E5070B-06D

S E R V I C E N O T E

E5070B ENA Series Network Analyzer, 300 kHz to 3 GHz

Change the RF signal path configuration and update firmware to 5.02 or later to improve the input damage level tolerance

**Figure 1 Front View (Semi-rigid Cables Opt. 213 before modification)**

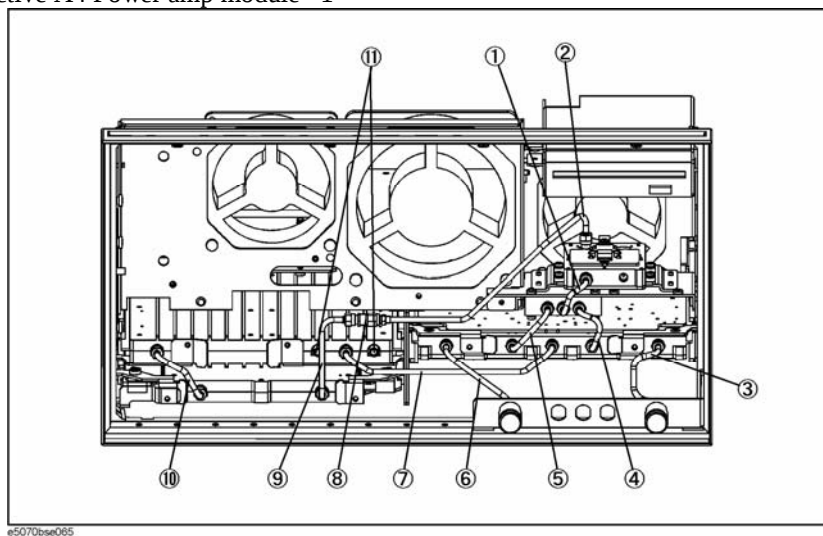
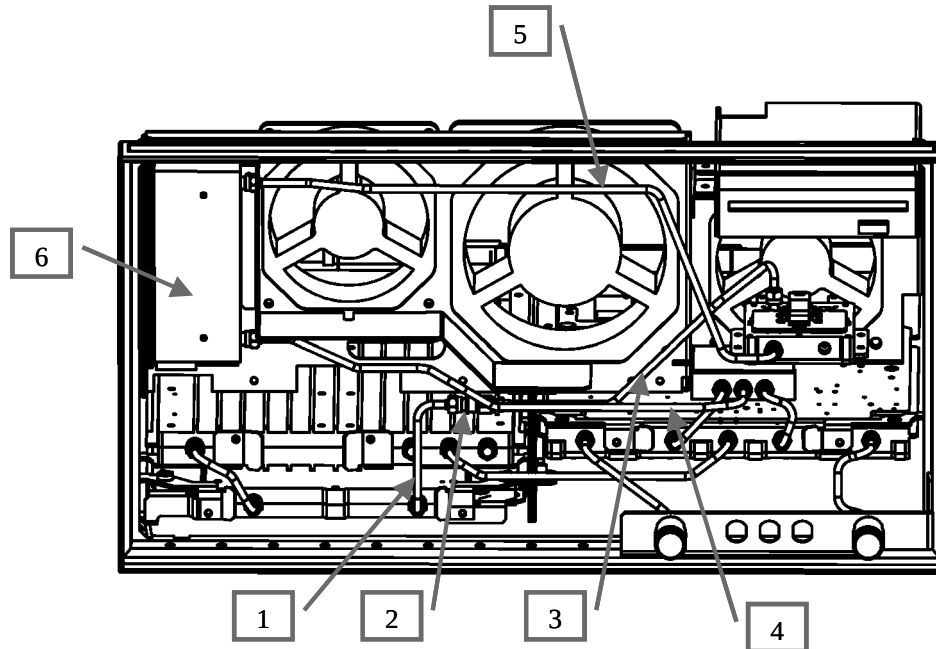
1. Remove outer cover. *1
2. Remove front panel. *1
3. Remove A28 Floppy Disk Drive (FDD) unit. *1
4. Remove semi-rigid cables in figure 1 No. 1 (E5070-61685) and No. 2 (E5070-61672)
5. Remove defective A4 Power amp module *1

8. Install new A4 power amp module to an original place.
9. Connect uW attenuator 0955-0208 (No 2 in Figure4) and A4 with E5070-61672 semi-rigid cable (No 3 in Figure 4)
10. Connect A4 and A7 ATT with E5070-61633 semi-rigid cable (No 5 in Figure 4)
11. Connect A7 ATT and A8 with E5070-61634 semi-rigid cable (No 4 in Figure 4)

Figure 4 Front View (Semirigid Cables Opt. 213, 214 after modification)

Figure 2 Make A7 attenuator assembly (for option 213)

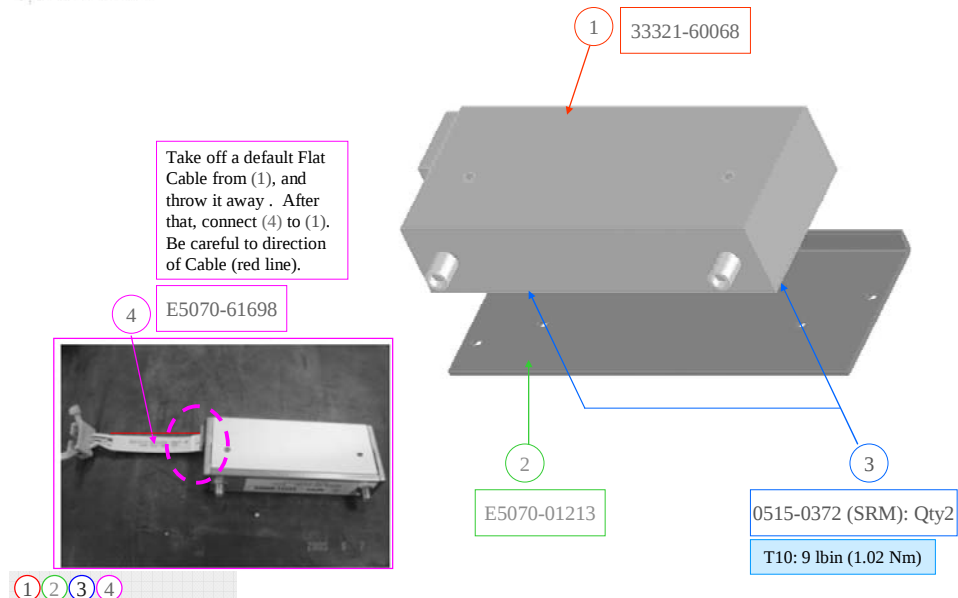
6. Make A7 step attenuator assembly by 33321-60068 (1ea), E5070-61698 (1ea), E5070-01213 (1ea), 0515-0372 (2ea) and E5070-61617 (1ea). E5070-61698 is the cable between 33321-60068 and E5070-61617.

Figure 3 Install A7 attenuator assembly (for option 213)

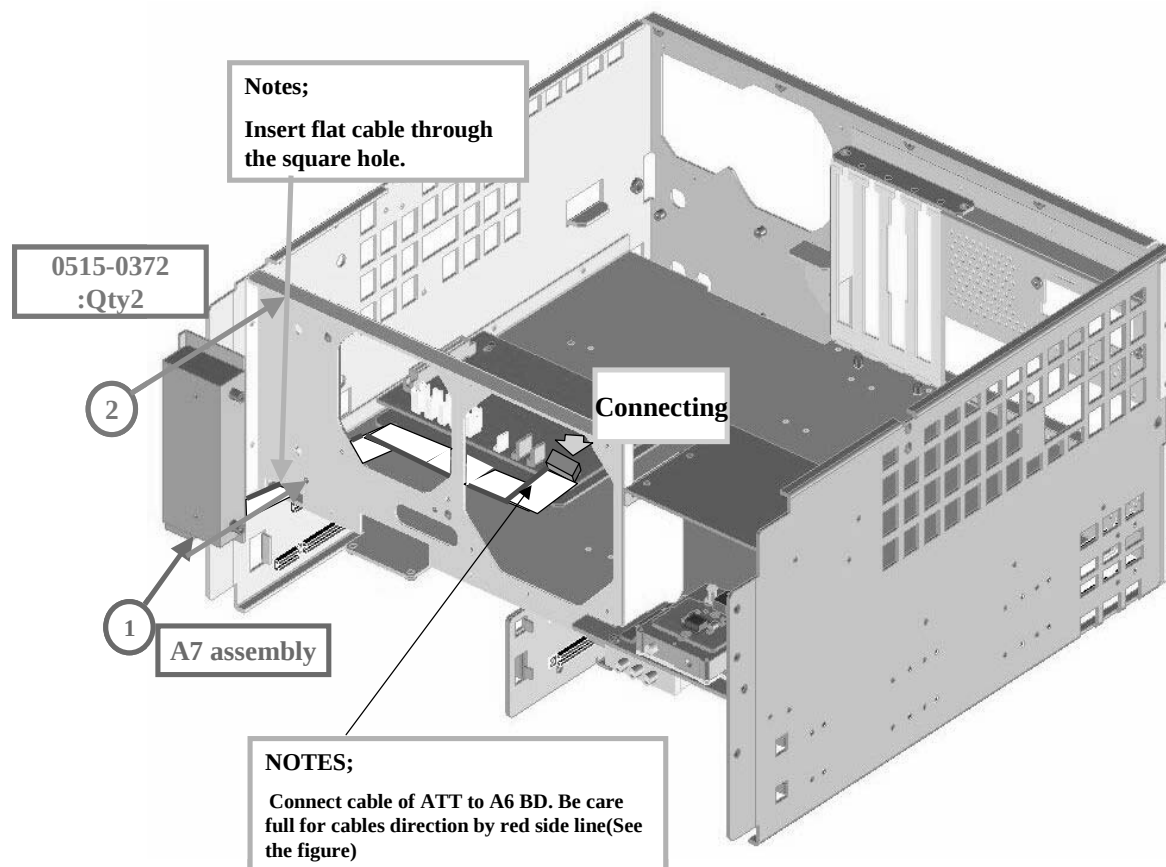
7. Install A7 assembly with 0515-0372 2 ea. Be careful to flat cable direction and its connectivity.

Figure 5 Front View (Miscellaneous Parts)

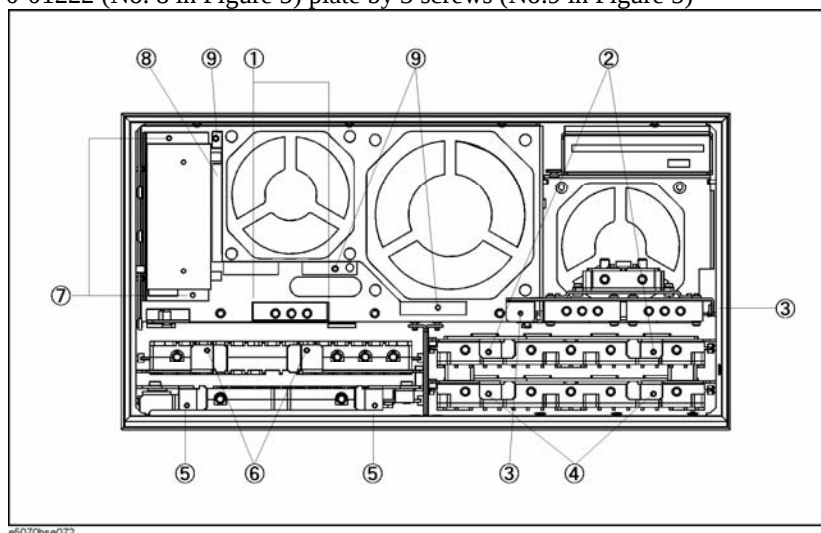
1. Remove outer cover. *1
2. Remove front panel. *1
3. Remove A28 Floppy Disk Drive (FDD) unit. *1
4. Remove E5070-01222 (No. 8 in Figure 5) plate by 3 screws (No.9 in Figure 5)

Figure 6 Front View (Semirigid Cables Opt. 214 before modification)

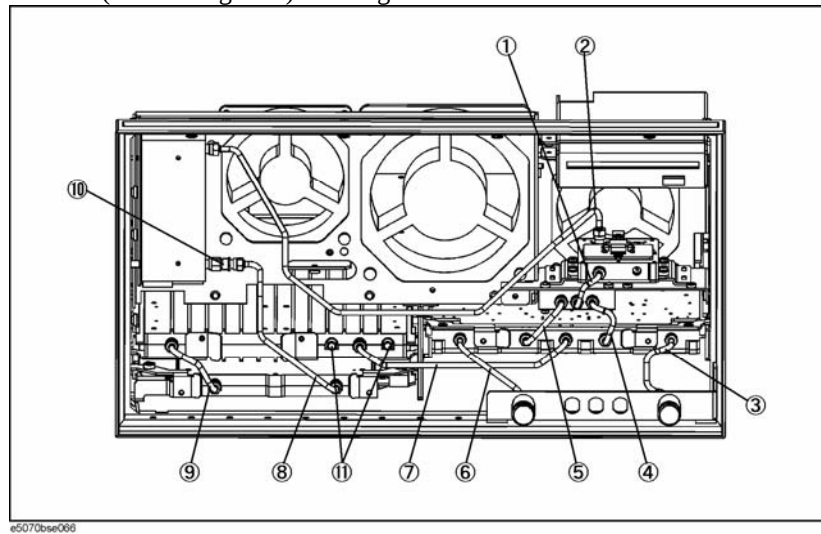
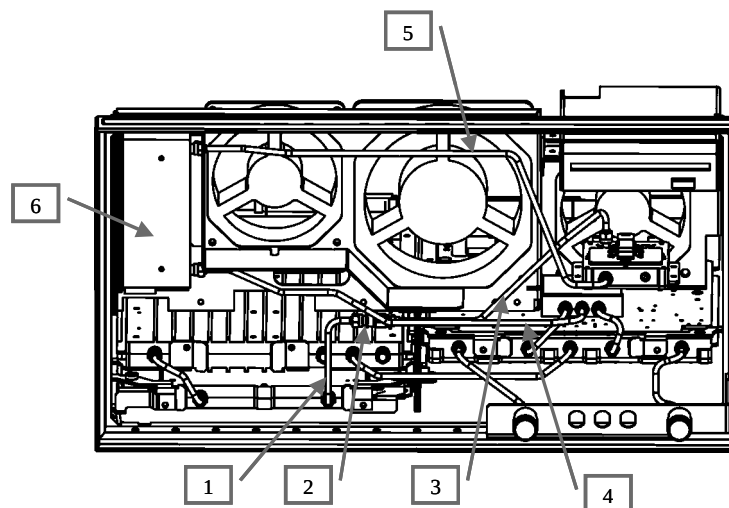
5. Remove E5070-61673 (No. 8 in Figure 6) semi-rigid cable from A3 and 0955-0208 (No 10 in Figure 6) attenuator
6. Remove 0955-0208 (No 10 in Figure 6) attenuator from A7 ATT module
7. Remove E5070-61674 (No 2 in Figure 6) semi-rigid cable from ATT and A4 amp
8. Remove E5070-61685 (No 1 in Figure 6) semi-rigid cable from A4 and A8 switch.

9. Remove defective A4 Power amp module *1
10. Remove A7 attenuator module by 2 screws.
11. Make new A7 attenuator module by 33321-60068 (1ea), E5070-61698 (1ea), E5070-61617 (1ea), 0515-0372 (2ea) and E5070-01213 (1ea). Scrap 33321-60059.
12. Install new A7 attenuator with 0515-0372 (2ea).
13. Install new A4 power amp module to an original place.
14. Connect A3 and 0955-0208 (No 2 in Figure 4, see below) attenuator with E5070-61671 (No 1 in Figure 4) semi-rigid cable
15. Connect 0955-0208 (No 2 in Figure 4) and A4 with E5070-61672 (No 3 in figure 4) semi-rigid cable
16. Connect A4 and ATT with E5070-61633 (No 5 in Figure 4) semi-rigid cable
17. Connect ATT and A8 with E5070-61634 (No 4 in Figure 4) semi-rigid cable
18. Screw E5070-01222 plate to the original place.
19. Set FDD unit.
20. Set front panel
21. Set outer cover

**Figure 7****Front View (Semi-rigid Cables Opt. 313 before modification)**

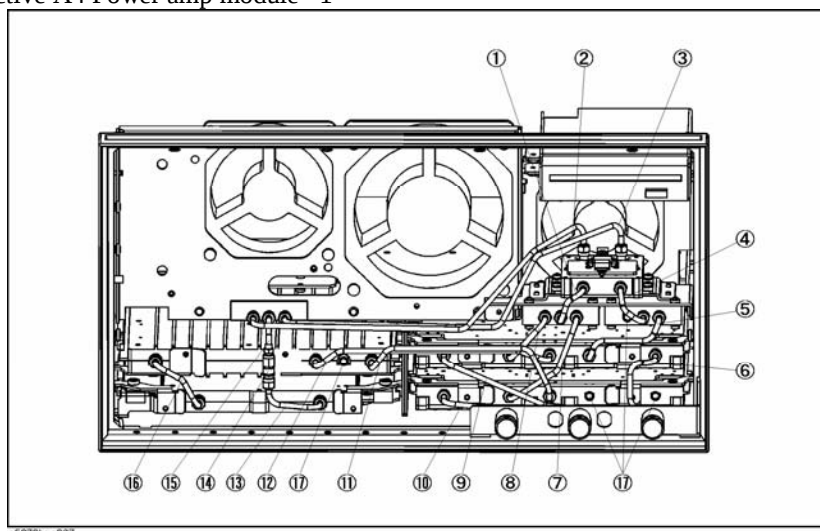
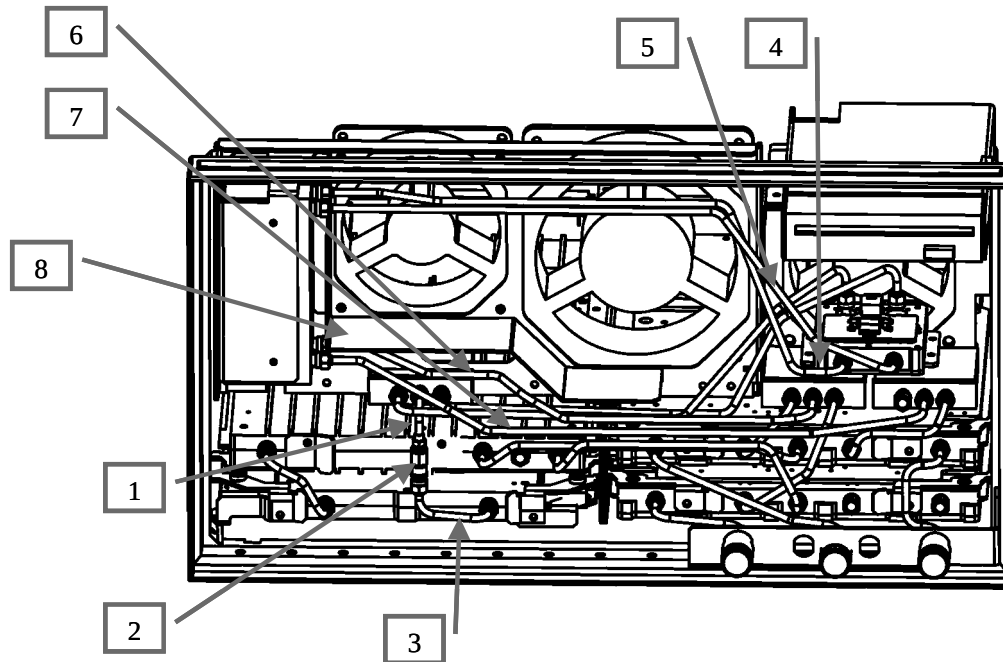
1. Remove outer cover. *1
2. Remove front panel. *1
3. Remove A28 Floppy Disk Drive (FDD) unit. *1
4. Remove E5070-01222 (No. 8 in Figure 5) plate by 3 screws (No.9 in Figure 5)
5. Remove E5070-61685 (No 1 and No 4 in Figure 7) semi-rigid cables from A4 and A8 (receiver side)
6. Remove E5070-61677 (No 2 in Figure 7) and E5070-61678 (No 3 in Figure 7) semi-rigid cables from A4 and A8 (source side)
7. Remove defective A4 Power amp module *1

10. Install new A4 power amp module to an original place.
11. Connect A8 (source side) and A4 with E5070-61677 and E5070-61678 that is removed in step 6.
12. Connect A4 and A7 ATT with E5070-61633 (No 4 in Figure10) semi-rigid cable
13. Connect A4 and A7 ATT with E5070-61635 (No 5 in Figure 10) semi-rigid cable
14. Connect ATT and A8 with E5070-61634 (No 6 in Figure 10) semi-rigid cable
15. Connect ATT and A8 with E5070-61636 (No 7 in Figure 10) semi-rigid cable

Figure 10 Front View (Semirigid Cables Opt. 313, 314 after modification)

Figure 8 Make A7 attenuator assembly (for option 313, 314, 413, 414)

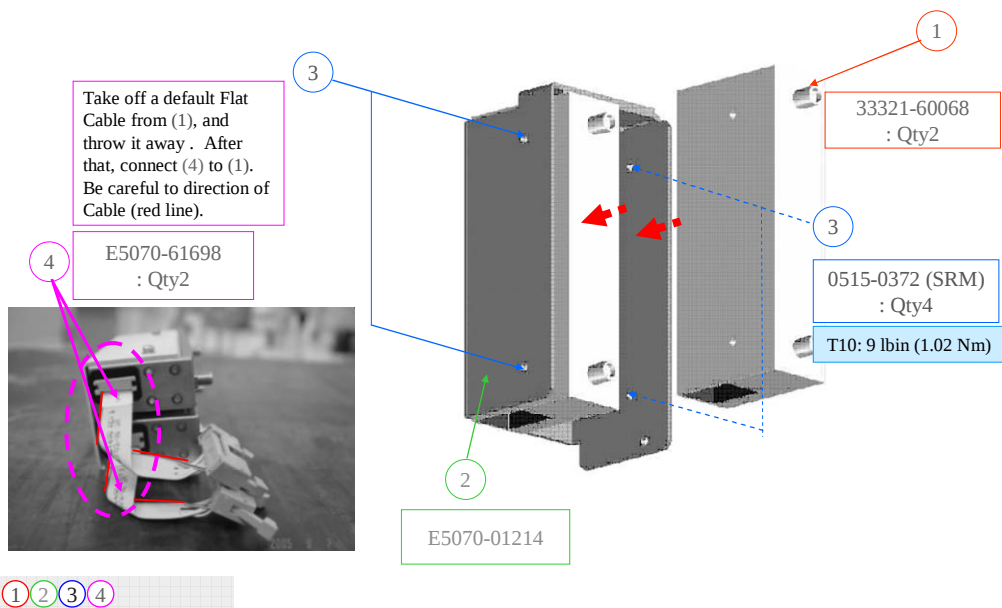
8. Make A7 step attenuator assembly by 33321-60068 (2ea), E5070-61698 (2ea), E5070-01214 (1ea), 0515-0372 (4ea) and E5070-61618 (1ea). 2ea of E5070-61698 is the cable between 33321-60068 and E5070-61618.

Figure 9 Install A7 attenuator assembly (for option 313, 314, 413, 414)

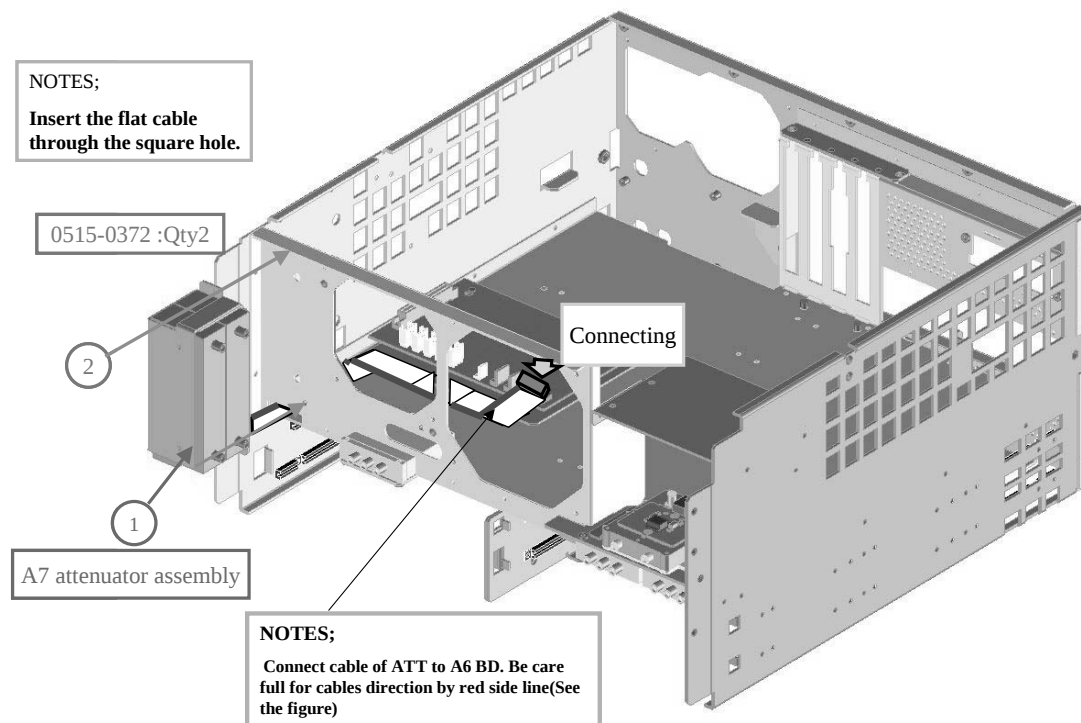
9. Install A7 assembly with 0515-0372 2 ea. Be careful to the flat cable's direction and connection.

Figure 11 New cable clamp position and cable bending reference

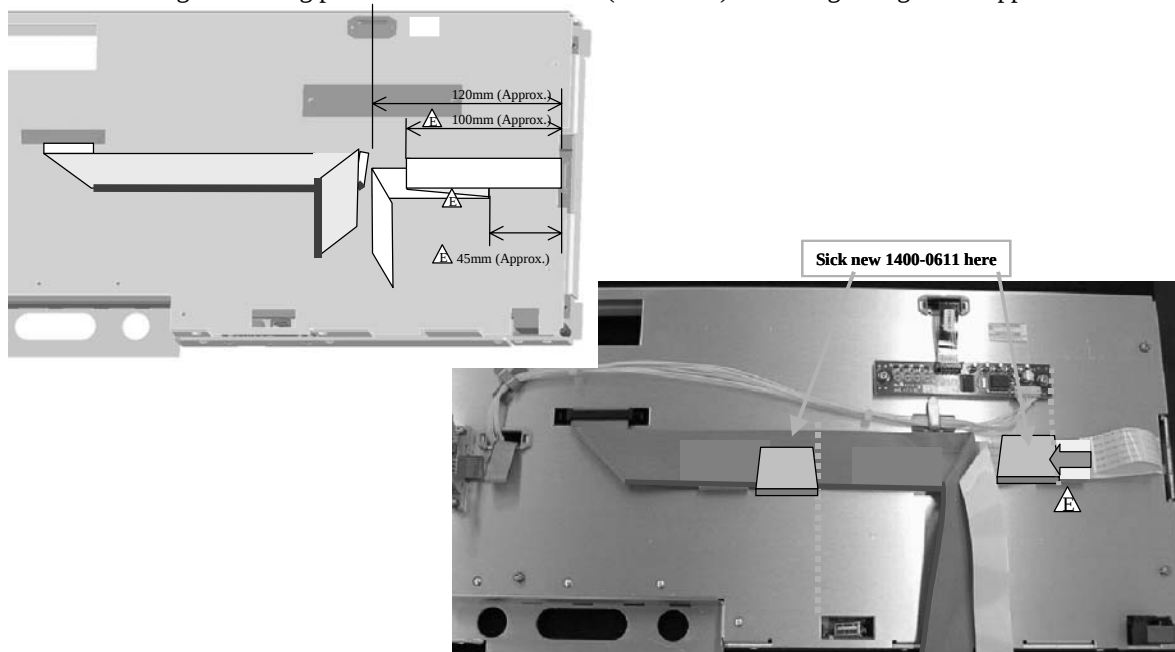
16. Screw E5070-01223 plate (No 8 in figure 10) instead of E5070-01222
17. To avoid the friction between new semi-rigid cables and front panel's cable clamp, remove two 1400-0611, cable clamp, from original place, then stick two new 1400-0611, cable clamp, as shown in Figure 11 lower. Then change a bending position of LCD flat cable (white one) according to Figure 11 upper.

Figure 12 Front View (Semirigid Cables Opt. 314 before modification)

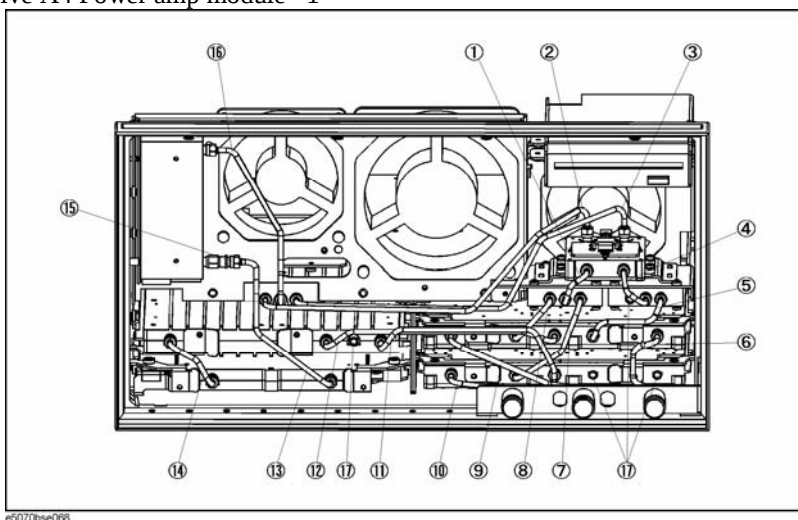
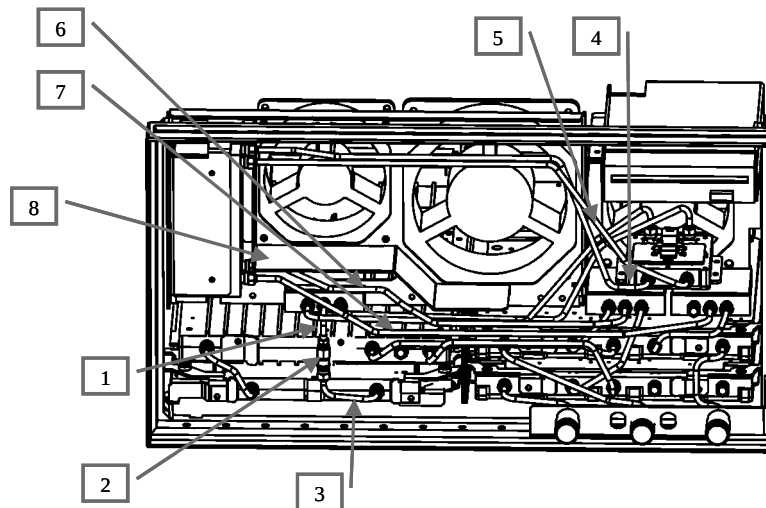
1. Remove outer cover. *1
2. Remove front panel. *1
3. Remove A28 Floppy Disk Drive (FDD) unit. *1
4. Remove E5070-01222 (No. 8 in Figure 5) plate by 3 screws (No.9 in Figure 5)
5. Remove E5070-61685 (No 1 and No 4 in Figure 12) semi-rigid cables from A4 and A8 (receiver side)
6. Remove E5070-61677 (No 2 in Figure 12) and E5070-61678 (No 3 in Figure 12) from A4 and A8 (source side)
7. Remove E5070-61673 (No 13 in Figure 12) semi-rigid cable from A3 and 0955-0301 (No 15 in Figure 12).
8. Remove 0955-0301 (No 15 in Figure 12) uW attenuator from A7 ATT
9. Remove E5070-61656 (No 16 in Figure 12) semi-rigid cable from A7 and A8
10. Remove defective A4 Power amp module *1

13. Install new A7 attenuator with 0515-0372 2 ea. Refer to Figure 9 for the detail.
14. Install new A4 power amp module to an original place
15. Connect A3 and 0955-0301 (removed in step 8) with E5070-61675 (No 3 in Figure 10, see below) semi-rigid cable

16. Connect 0955-0301 and A8 (source side) with E5070-61676 (No 1 in Figure 10)
17. Connect A8 (source side) and A4 with E5070-61677 and E5070-61678 that are removed in step 6

18. Connect A4 and A7 ATT with E5070-61633 (No 4 in Figure 10) semi-rigid cable
19. Connect A4 and A7 ATT with E5070-61635 (No 5 in Figure 10) semi-rigid cable

20. Connect ATT and A8 with E5070-61634 (No 6 in Figure 10) semi-rigid cable
21. Connect ATT and A8 with E5070-61636 (No 7 in Figure 10) semi-rigid cable

22. Screw E5070-01223 plate (No 8 in figure 10) instead of E5070-01222
23. To avoid the friction between new semi-rigid cables and front panel's cable clamp, remove two 1400-0611, cable clamp, from original place, then stick two new 1400-0611, cable clamp, as shown in Figure 11 lower. Then change a bending position of LCD flat cable (white one) according to Figure 11 upper

Figure 13 Front View (Semirigid Cables Opt. 413 before modification)

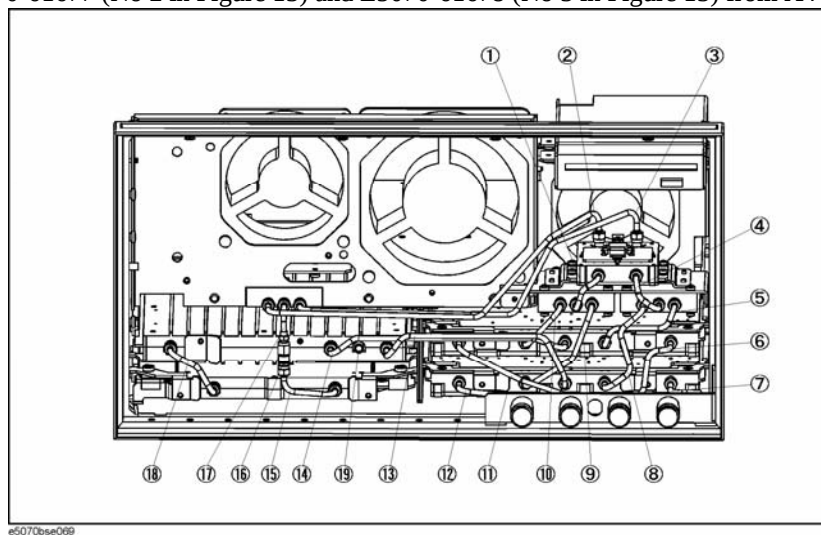
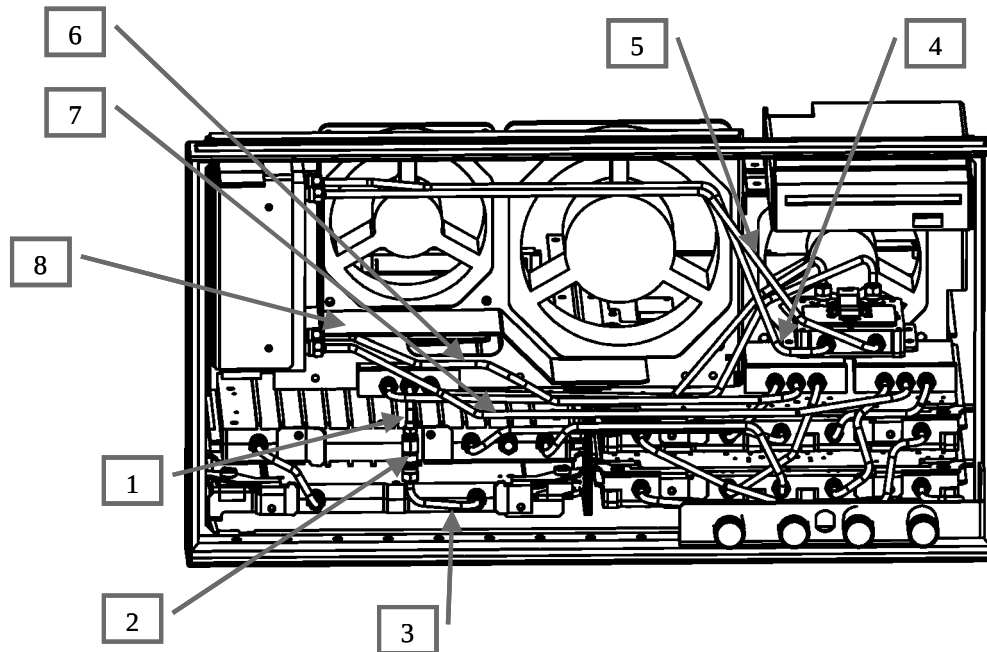
1. Remove outer cover. *1
2. Remove front panel. *1
3. Remove A28 Floppy Disk Drive (FDD) unit. *1
4. Remove E5070-01222 (No. 8 in Figure 5) plate by 3 screws (No.9 in Figure 5)
5. Remove E5070-61685 (No 1 and No 4 in Figure 13) semi-rigid cables from A4 and A8 (receiver side)
6. Remove E5070-61677 (No 2 in Figure 13) and E5070-61678 (No 3 in Figure 13) from A4 and A8 (source side)

8. Make A7 step attenuator assembly by 33321-60068 (2ea), E5070-61698 (2ea), E5070-01214 (1ea), 0515-0372 (4ea), and E5070-61618 (1ea). Refer to Figure 8 for the detail.
9. Install A7 assembly with 0515-0372 2 ea. Be careful to the flat cable's direction and connection. Refer to Figure 9 for the detail.
10. Install new A4 power amp module to an original place
11. Connect A8 (source side) and A4 with E5070-61677 and E5070-61678 that are removed in step 6
12. Connect A4 and A7 ATT with E5070-61633 (No 4 in Figure14) semi-rigid cable
13. Connect A4 and A7 ATT with E5070-61635 (No 5 in Figure 14) semi-rigid cable
14. Connect ATT and A8 with E5070-61634 (No 6 in Figure 14) semi-rigid cable
15. Connect ATT and A8 with E5070-61636 (No 7 in Figure 14) semi-rigid cable
16. Screw E5070-01223 plate (No 8 in figure 14) instead of E5070-01222

Figure 14 Front View (Semirigid Cables Opt. 413, 414 after modification)
